**Re: 40 to 60 Emma Street  
Comments for Site Plan Stage  
Project No.: 300056012.0000**

The application will be required to obtain site plan approval. As comments related to the site plan stage are more detailed, these comments have been provided separately from the Official Plan/Zoning Amendment applications.

Enclosure(s)      Red-Marked Pages from Servicing Brief

SHEET NUMBER:  
PRE-1

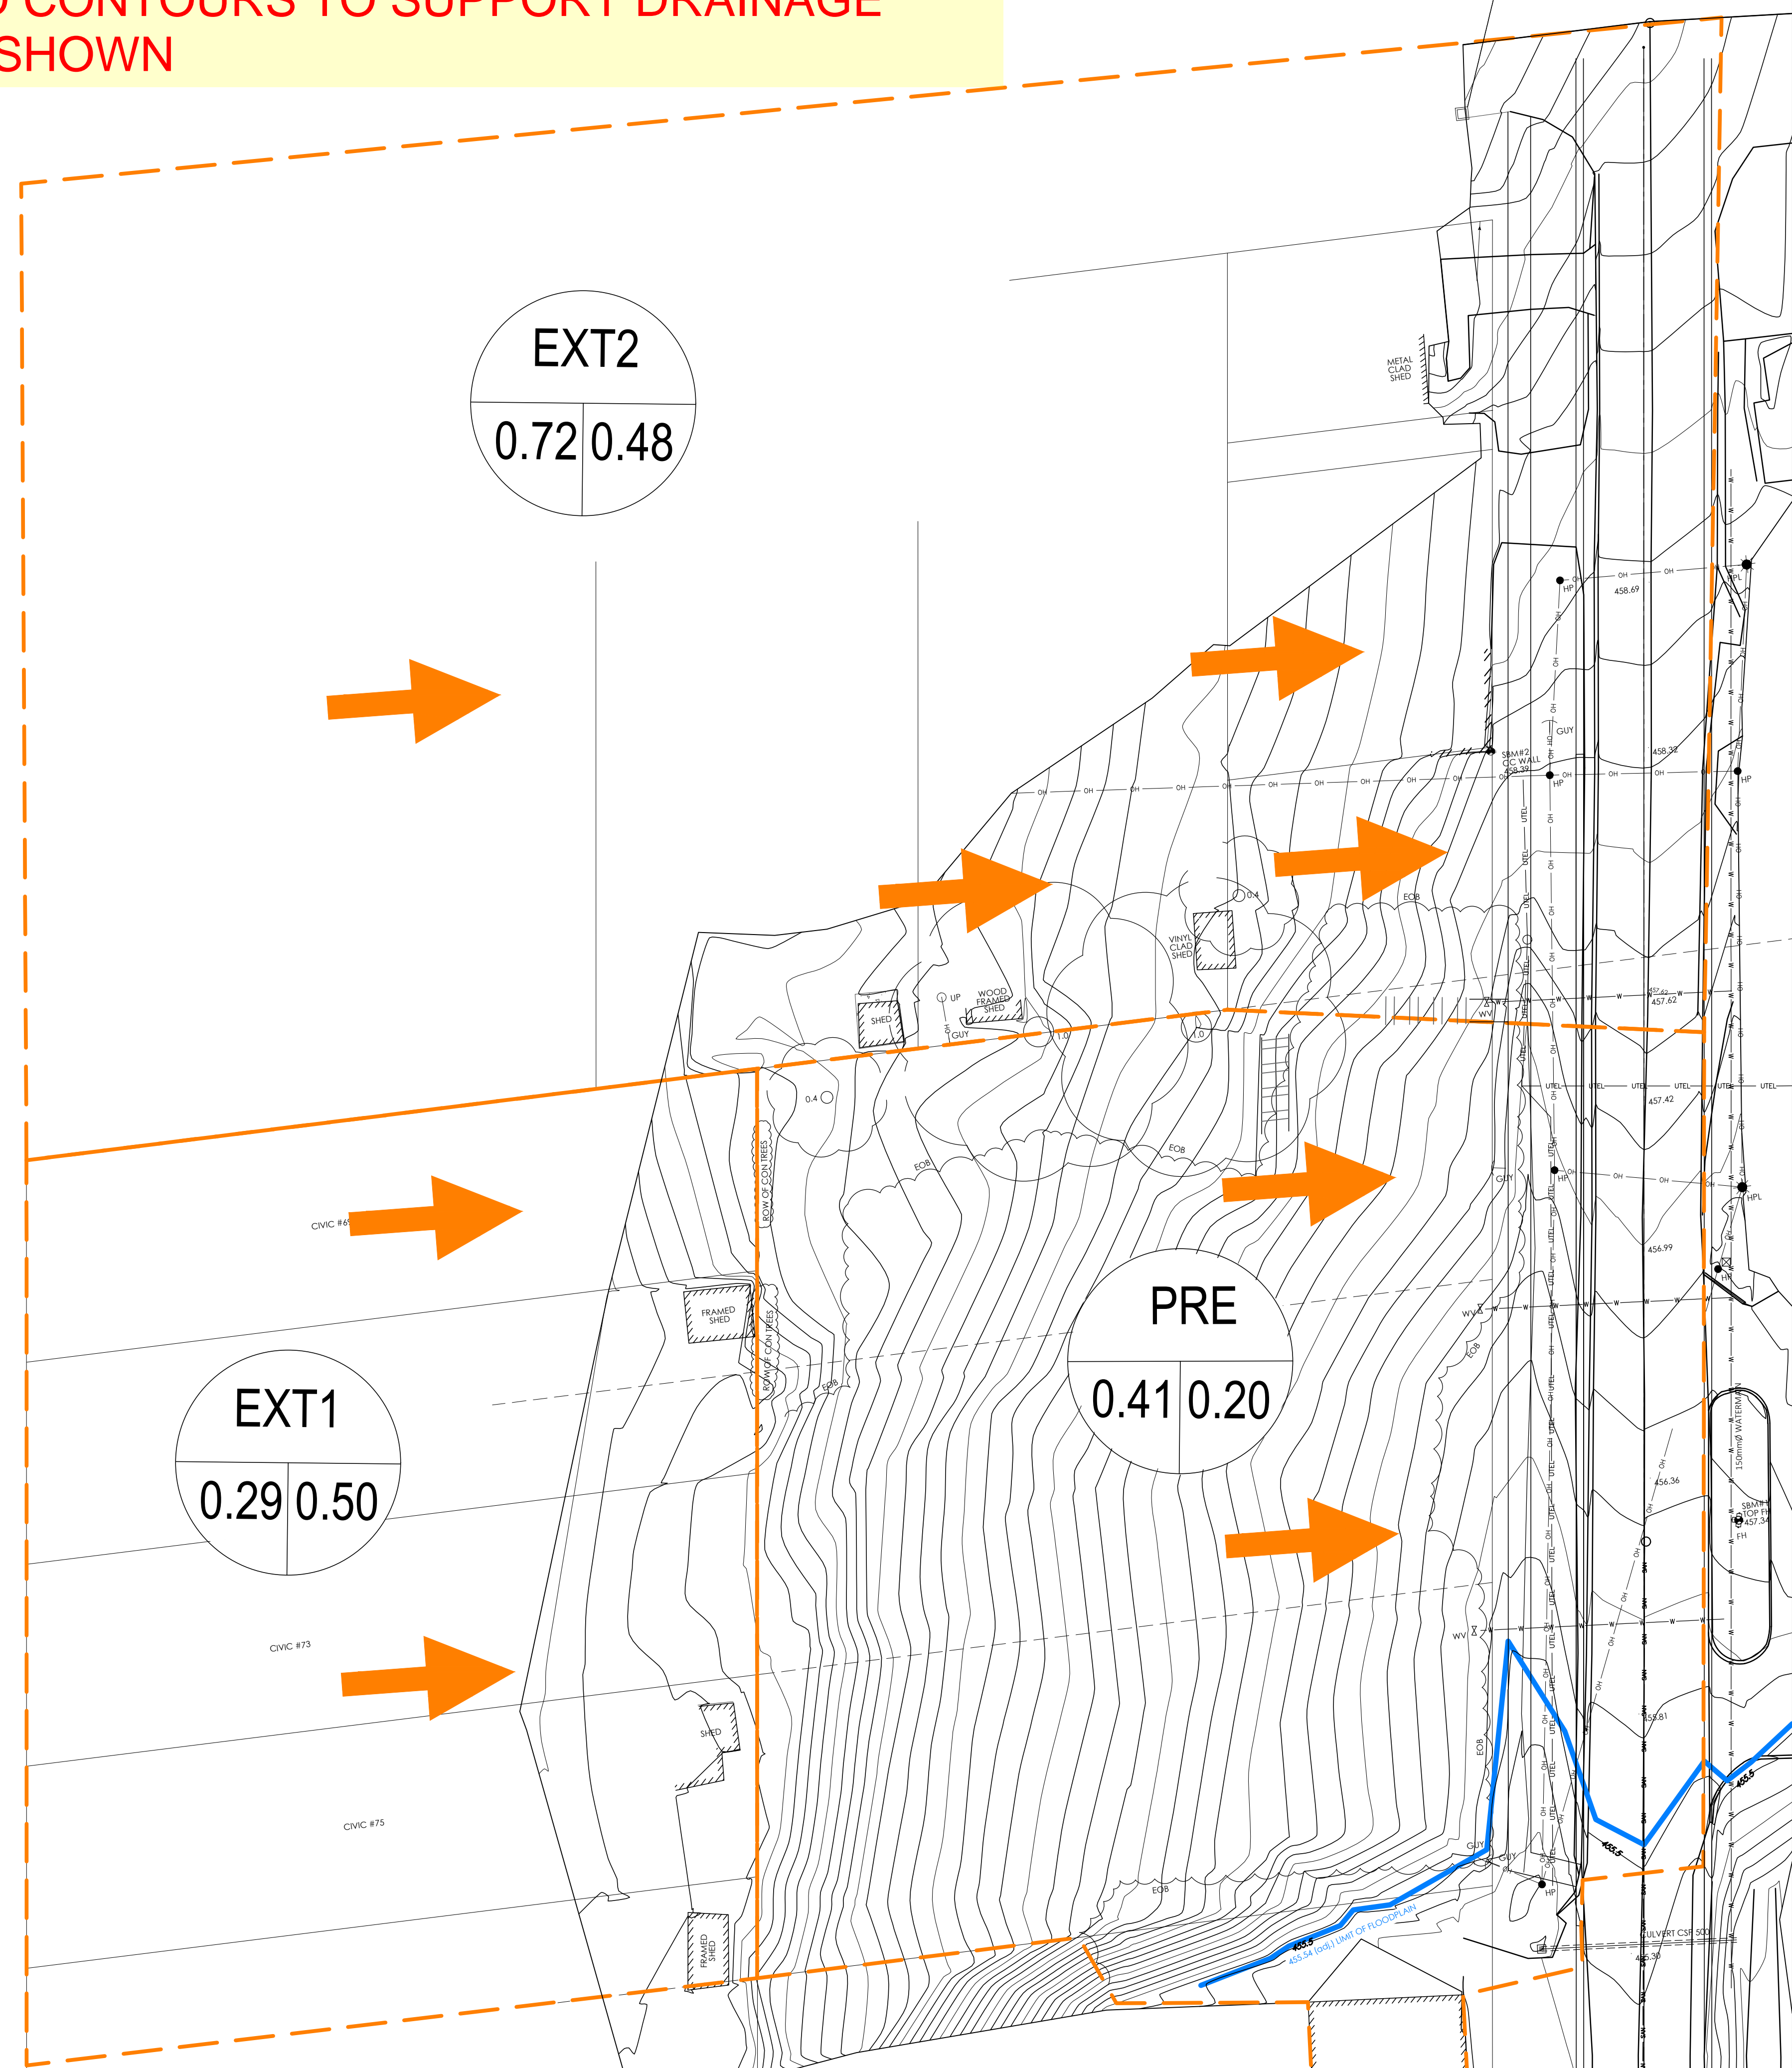
**EXTEND CONTOURS TO SUPPORT DRAINAGE  
AREAS SHOWN**

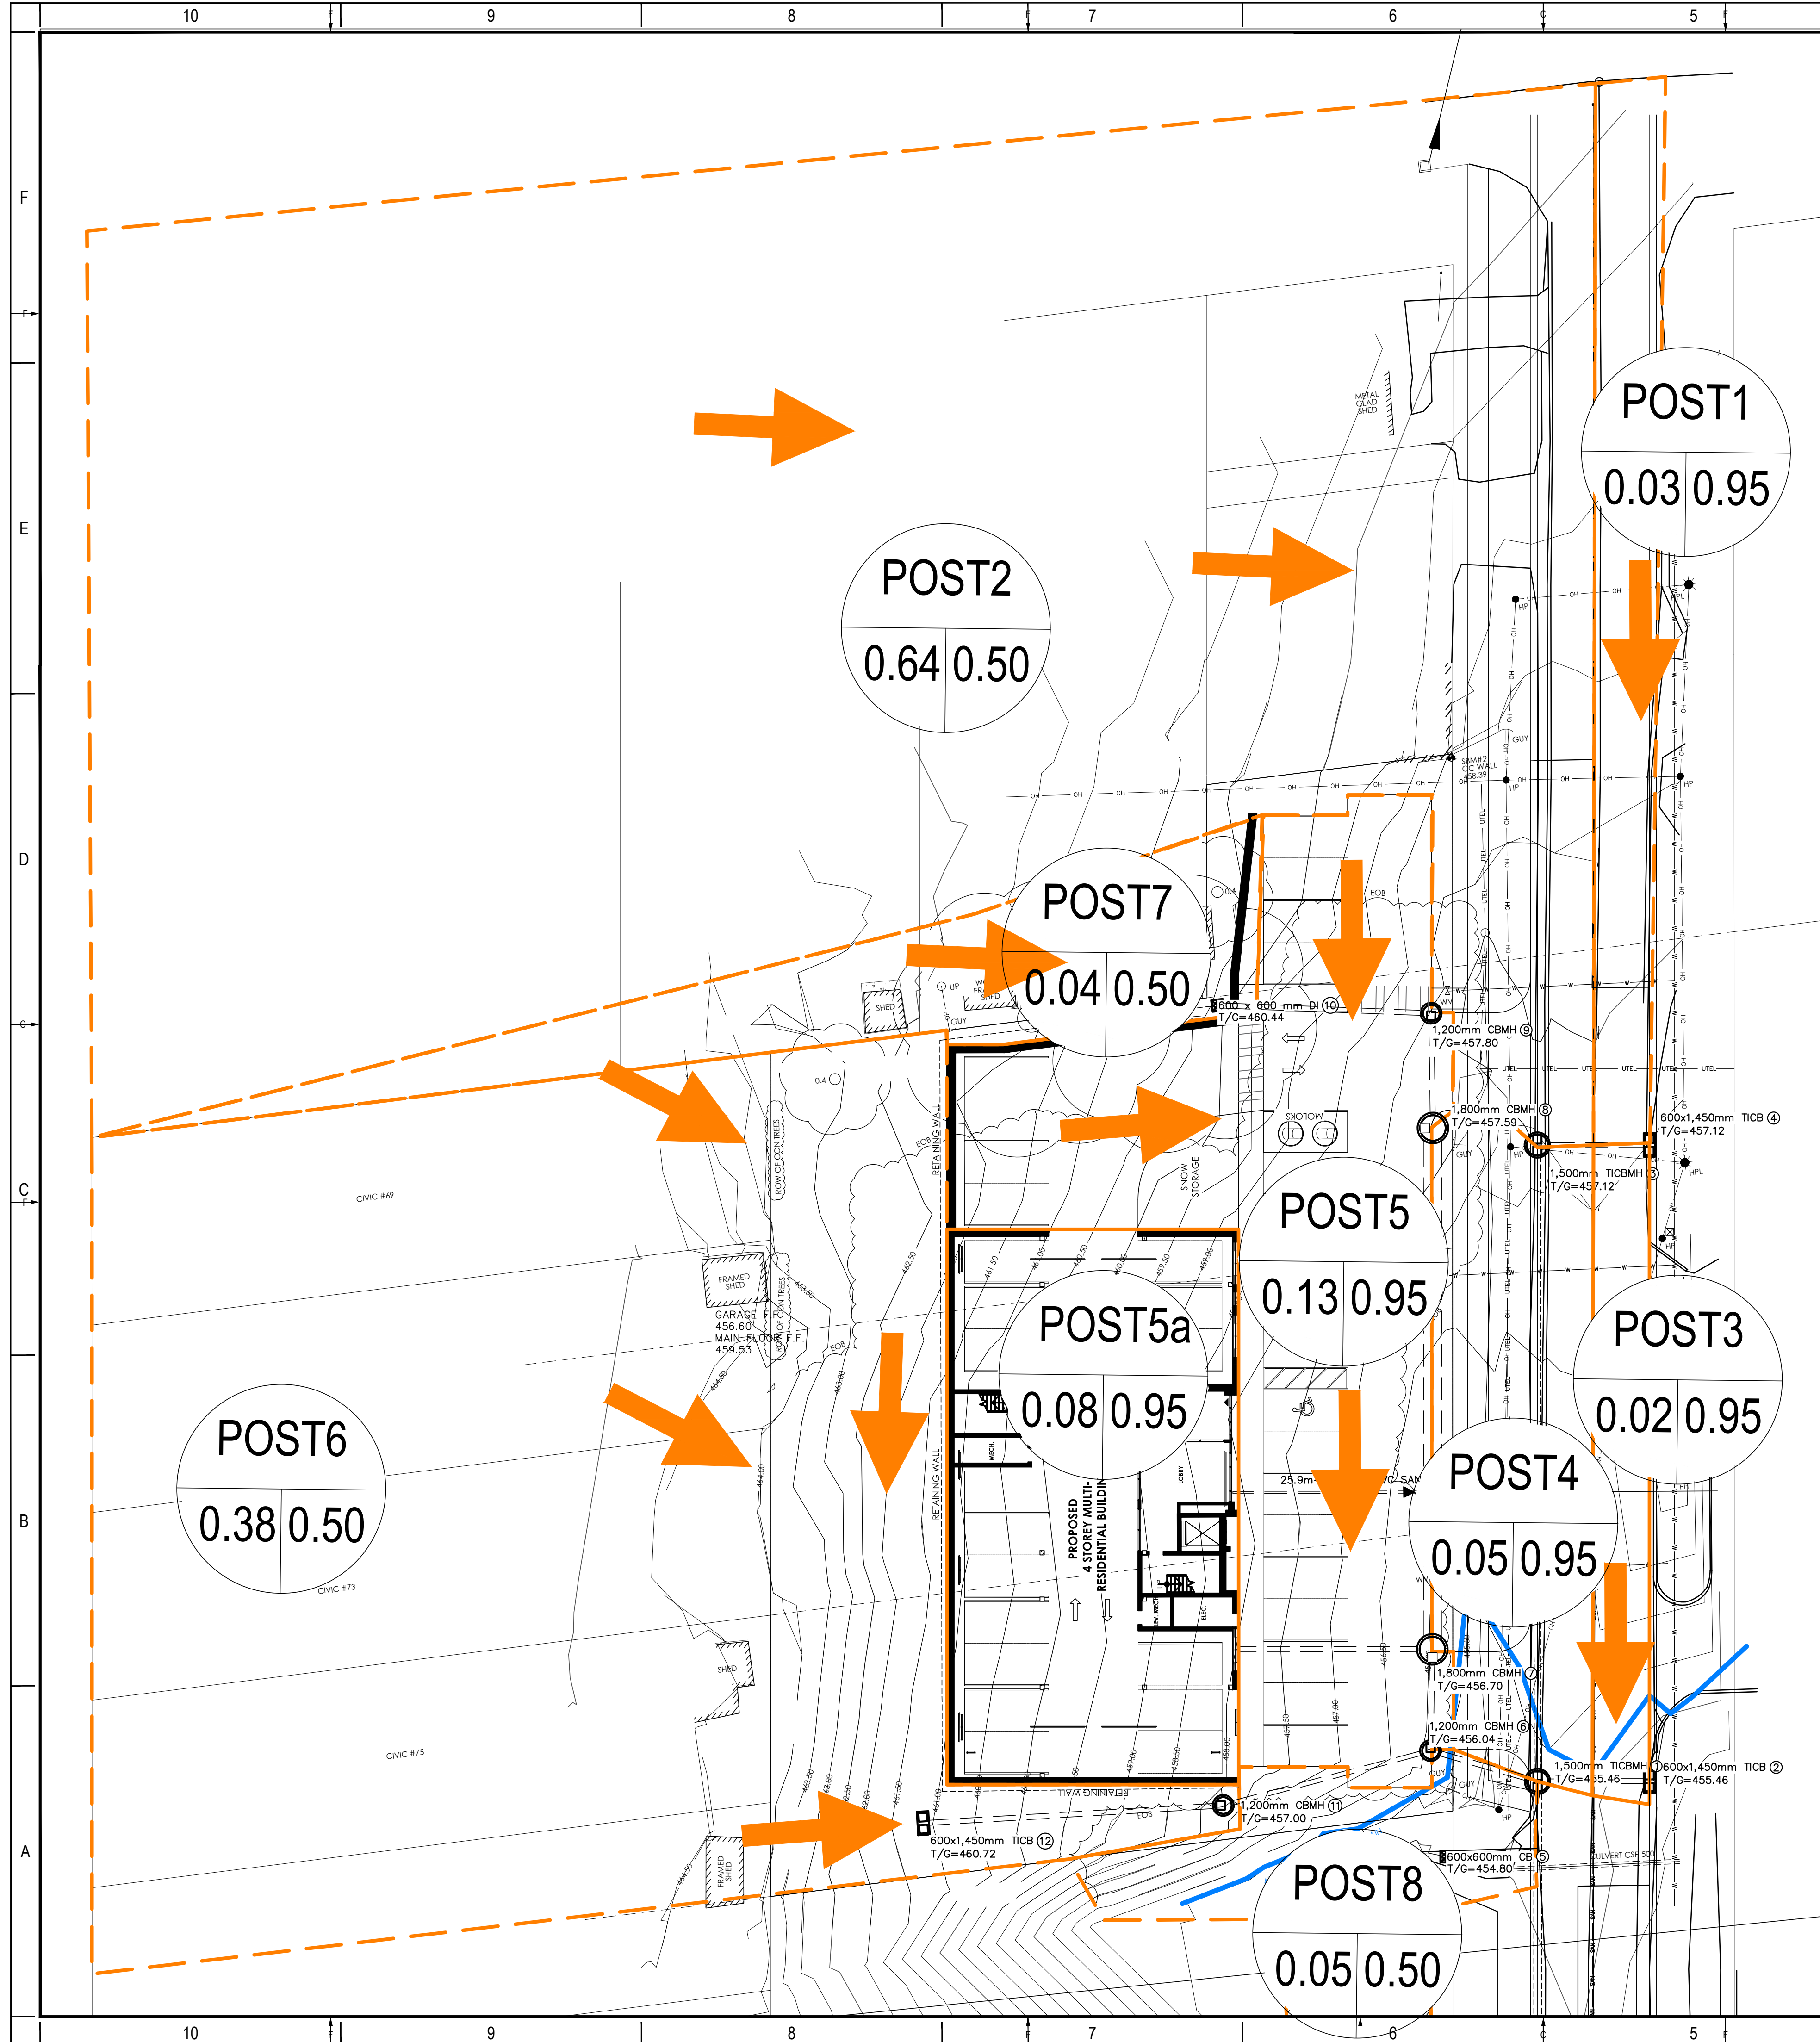
**Extend Contours**

**Review drainage areas/grading plan and what is getting into the system that is controlled. The review will require an update to the SWM analysis.**

**Refer to drainage area comments in letter.**

Drawings show 200mm dia. orifice

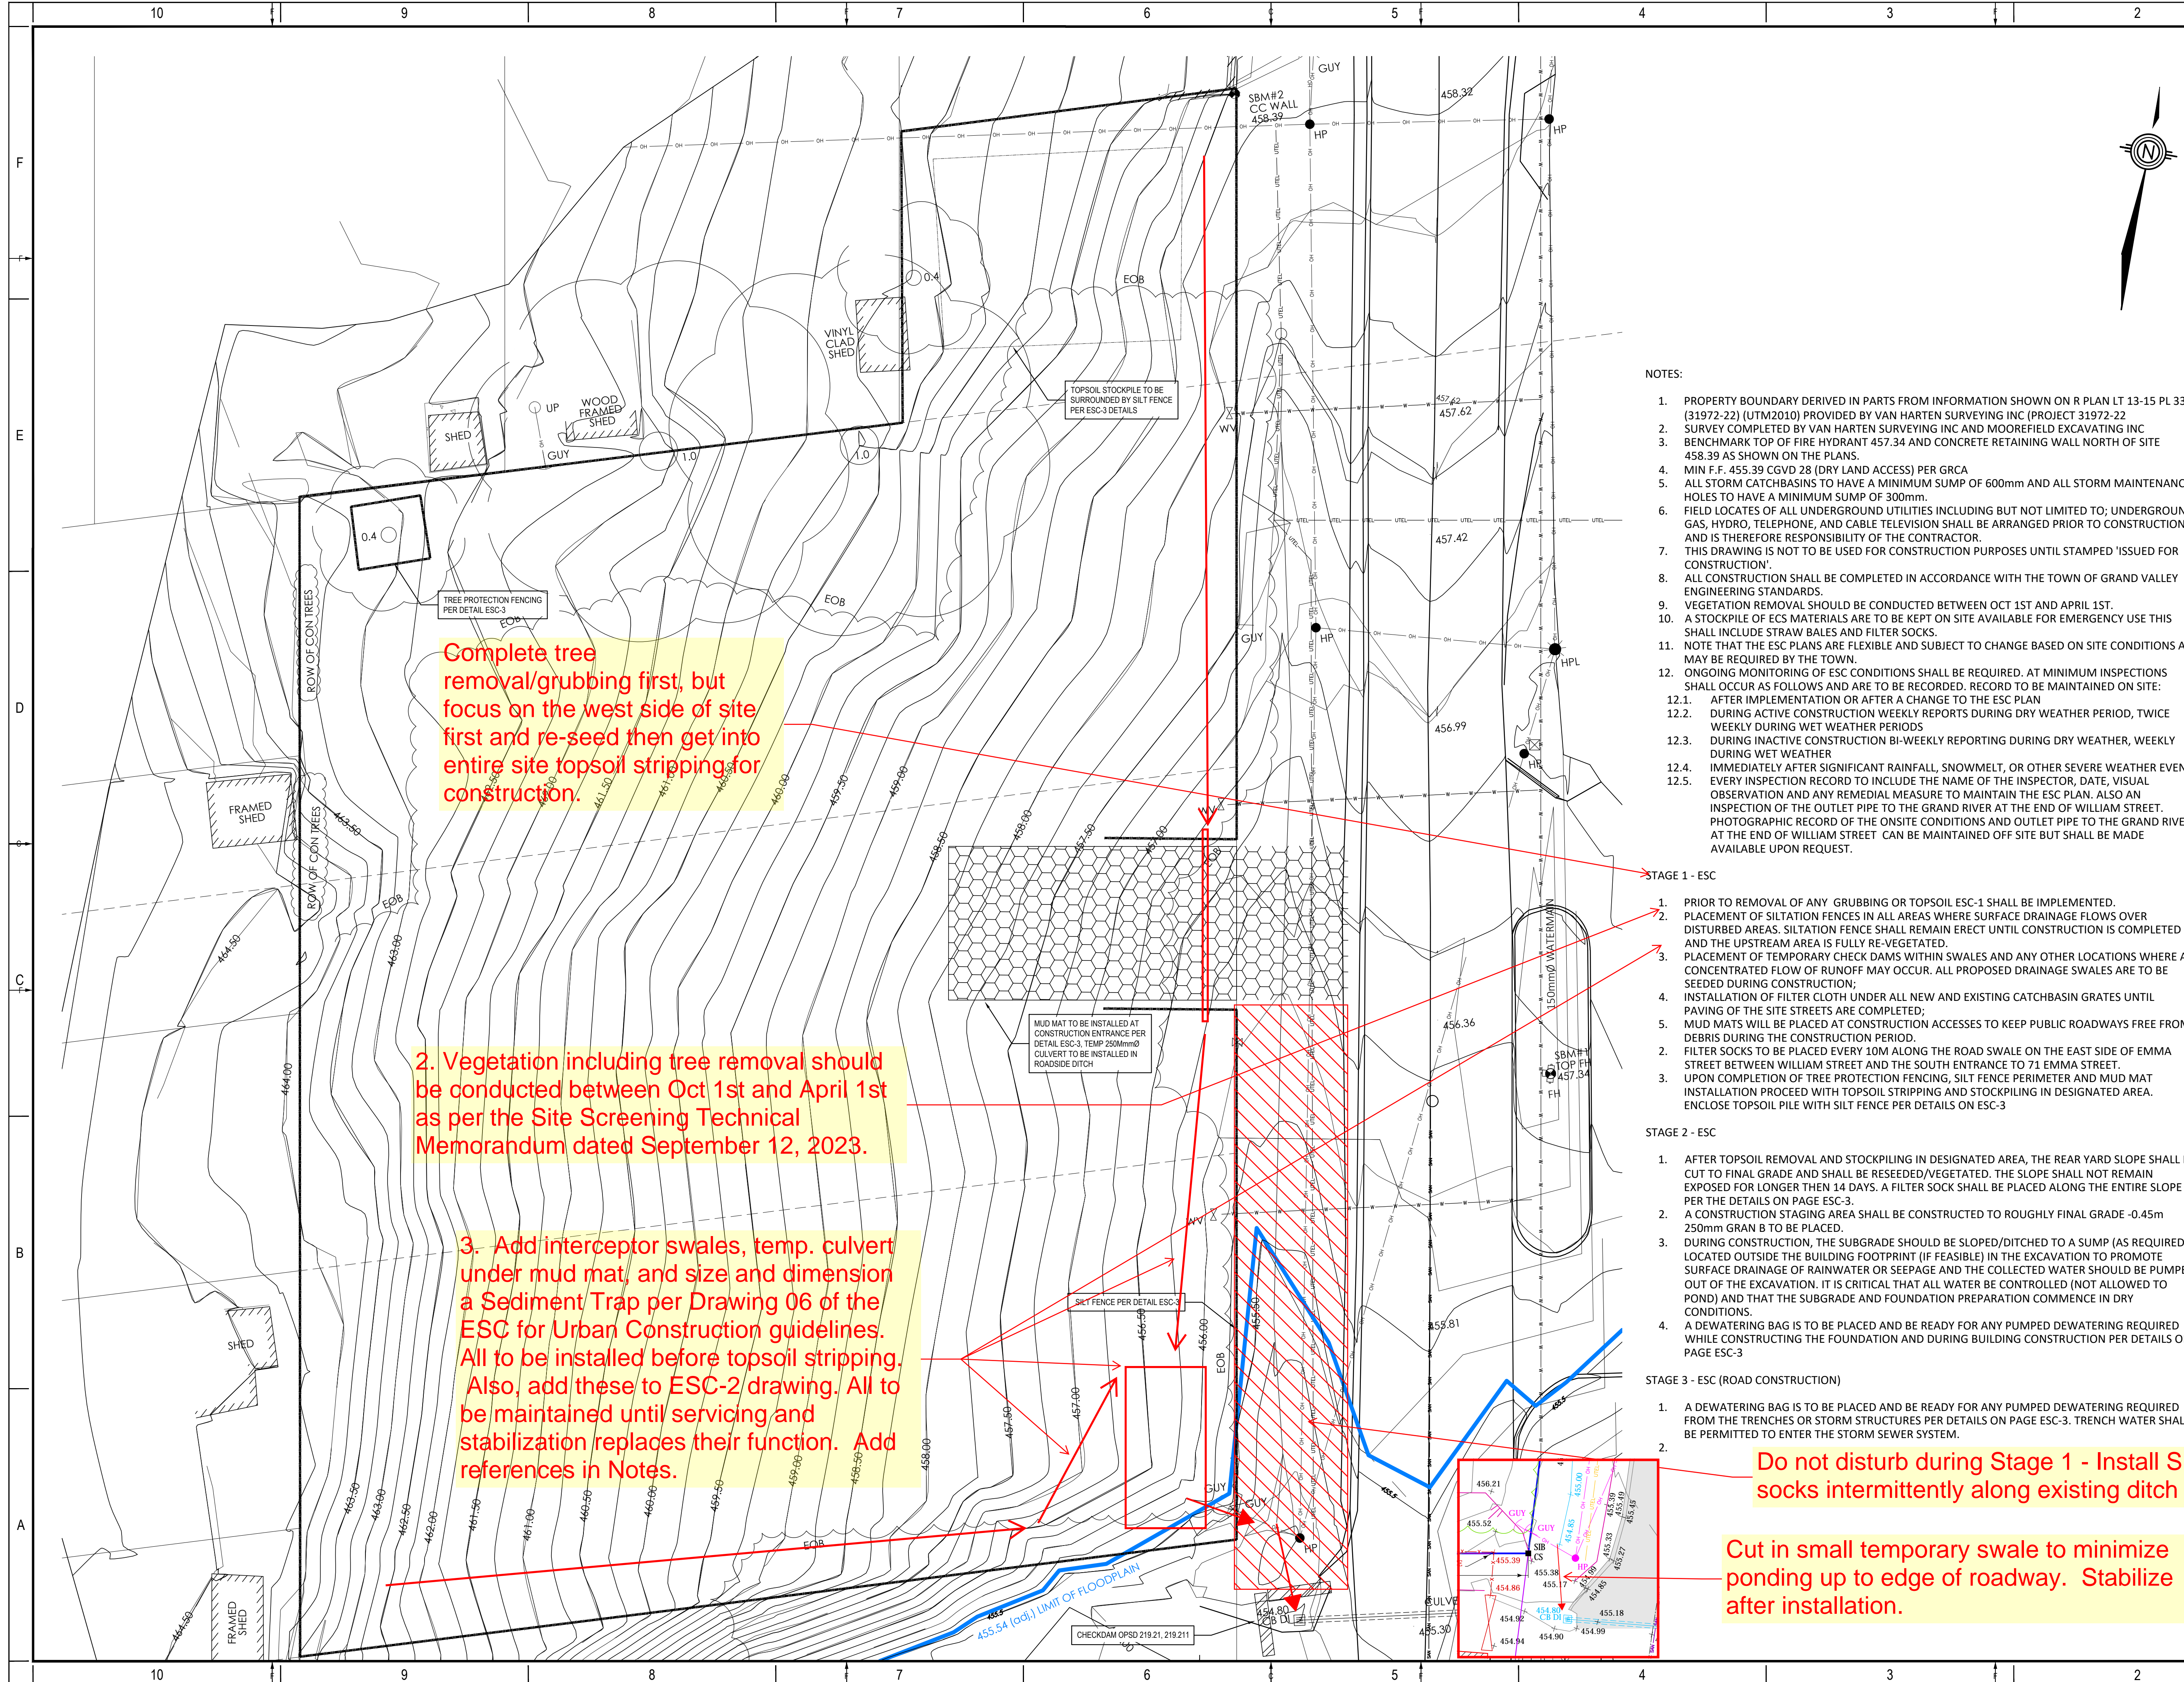
The dead end cbmh could have a sump however for flow-through cbmh's no sumps should be installed.

The OGS should not treat flow from area Post 6 as it has little pavement area
